EPC STORMWATER REVIEW COMMENTS
IN ORANGE BOXES WITH BLACK TEXT

**FINAL DRAINAGE REPORT
FOR
WATERSIDE AT LAKE WOODMOOR
FILING NO. 1**

April 2023

WATERSIDE AT LAKE WOODMOOR FILING NO. 1 FINAL DRAINAGE REPORT EXISTING CONDITIONS MAP			
DESIGNED BY	MAL	SCALE	DATE
DRAWN BY	MAL	(H) 1" = 40'	SHEET 1 OF 1
CHECKED BY	(V) 1" = N/A	JOB NO.	2588.00

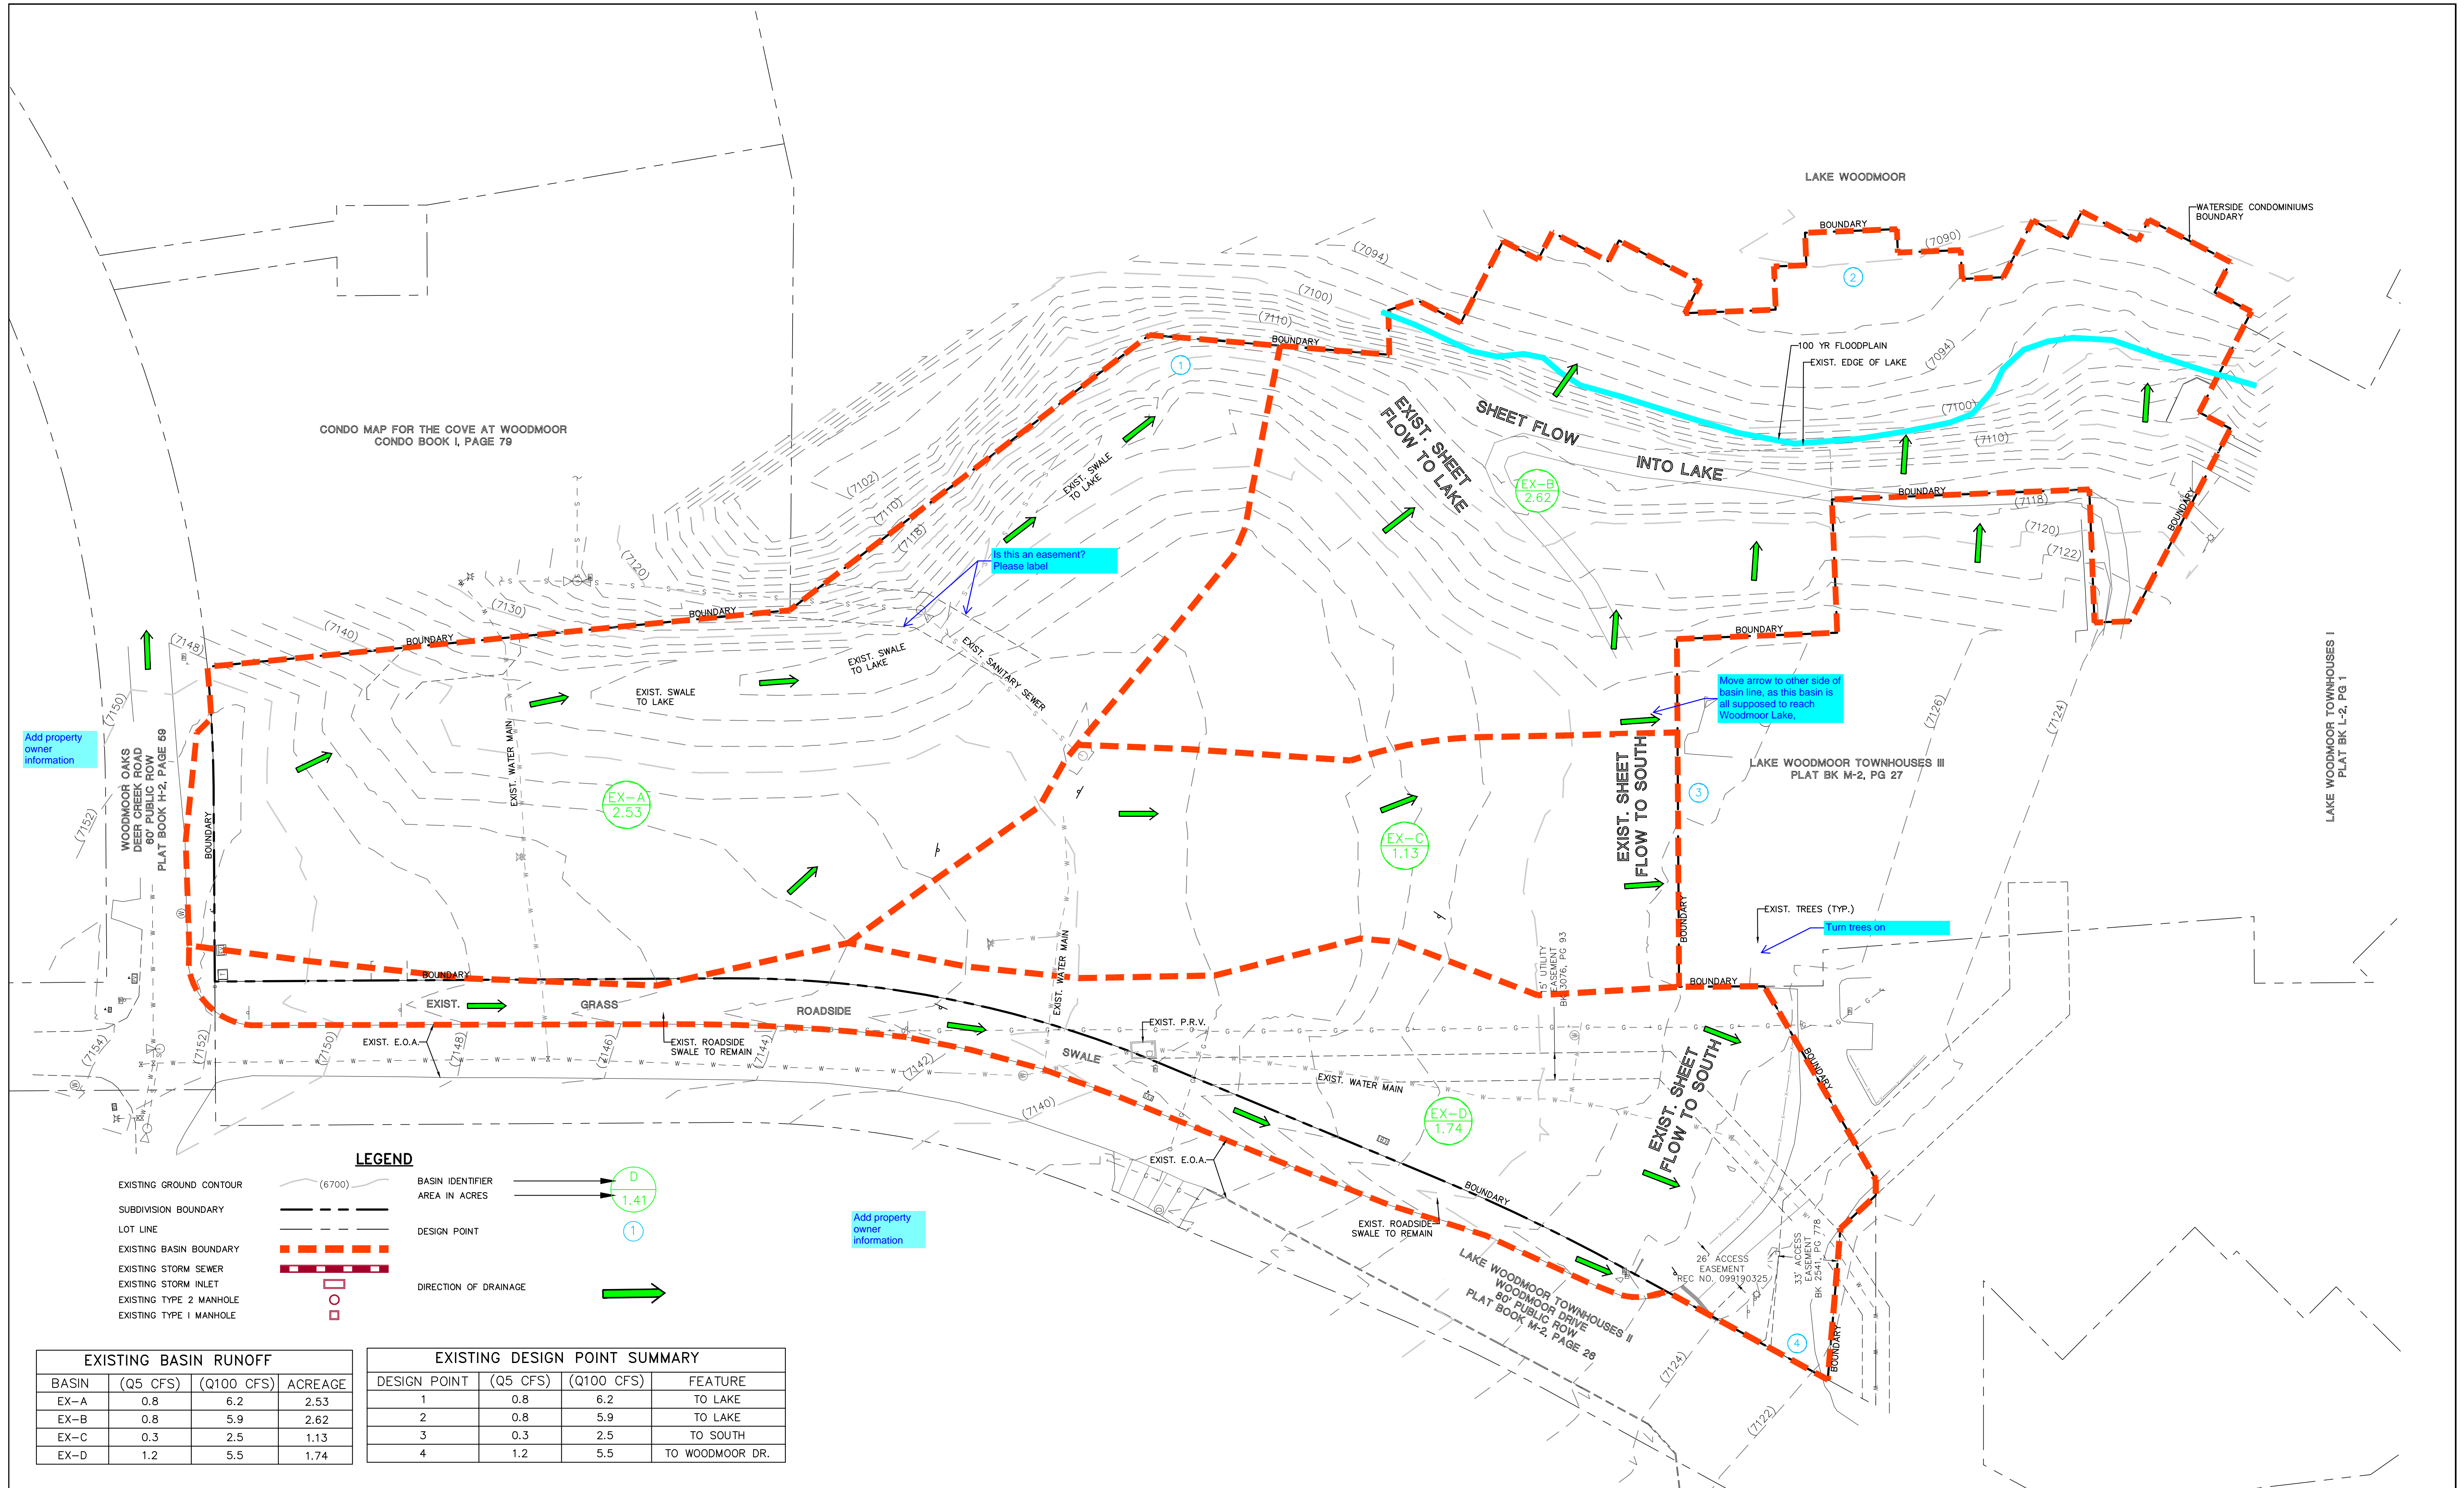
Add property
owner
information

Add property
owner
information

WATERSIDE AT LAKE WOODMOOR
 FILING NO. 1
 FINAL DRAINAGE REPORT
 DEVELOPED CONDITIONS MAP
 DESIGNED BY: MAL SCALE: DATE: 02/06/23
 DRAWN BY: MAL (H) 1"= 40' SHEET 1 OF 1
 CHECKED BY: (V) 1"= N/A JOB NO. 2588.00

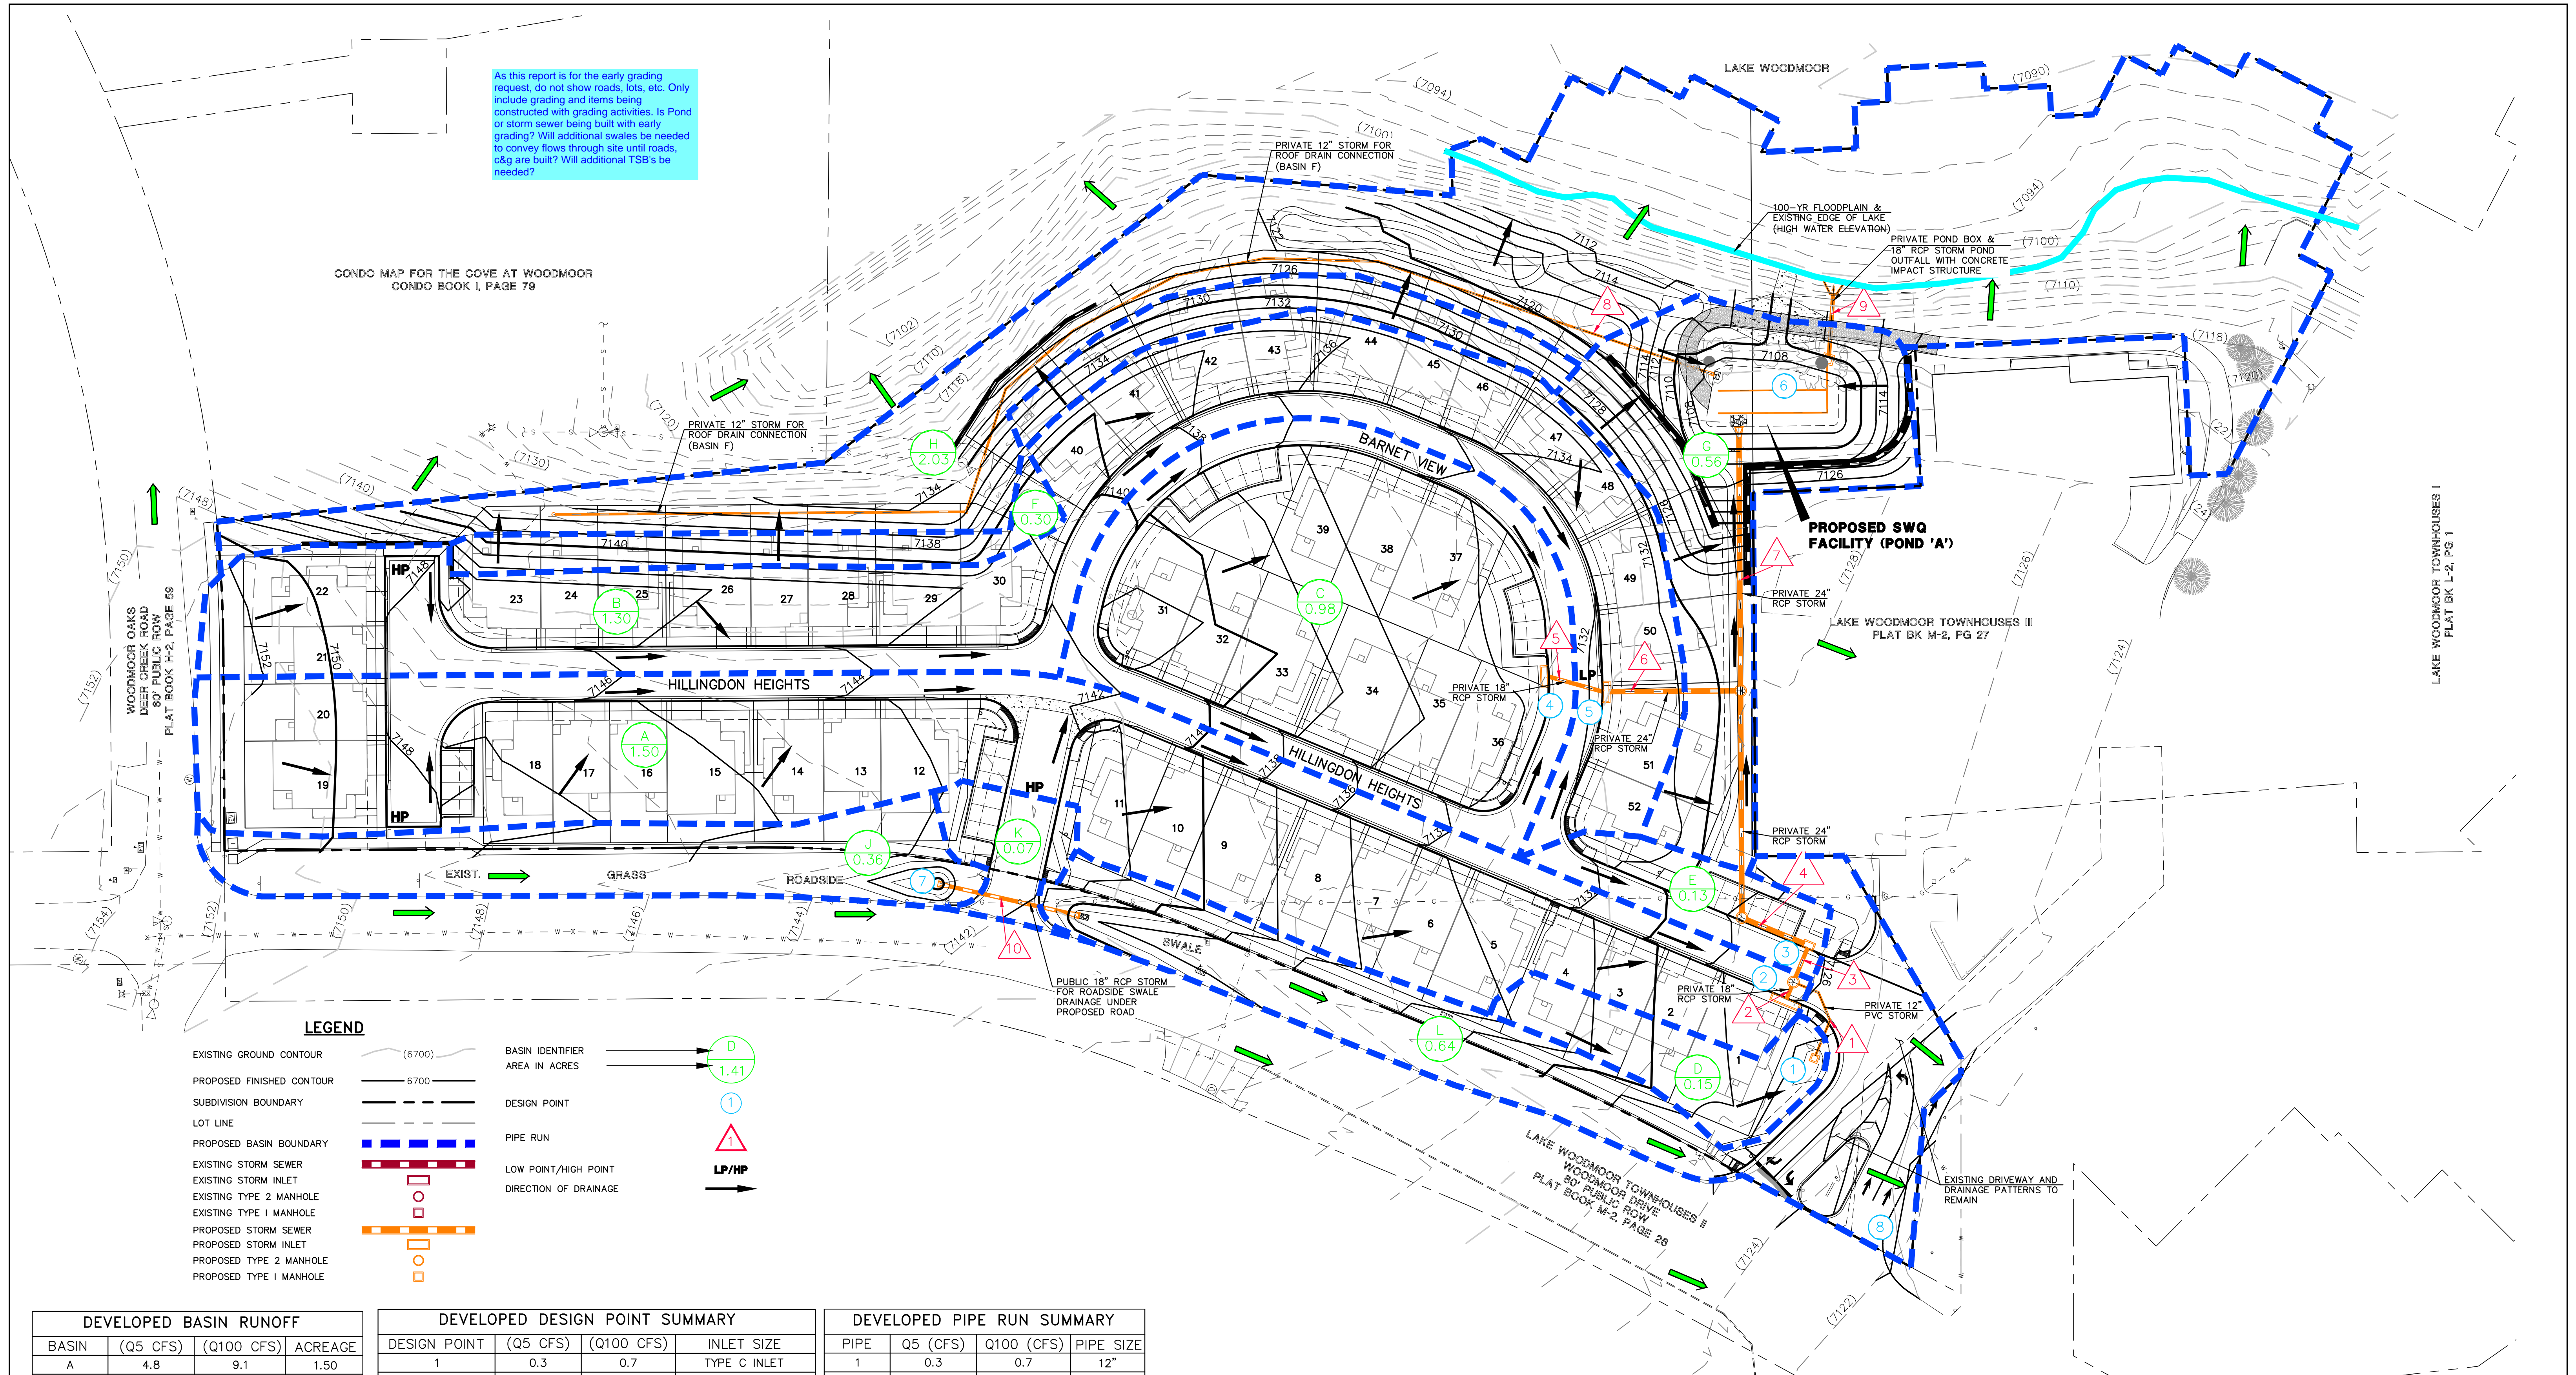
As this report is for the early grading request, do not show roads, lots, etc. Only include grading and items being constructed with grading activities. Is Pond or storm sewer being built with early grading? Will additional swales be needed to convey flows through site until roads, c&g are built? Will additional TSB's be needed?
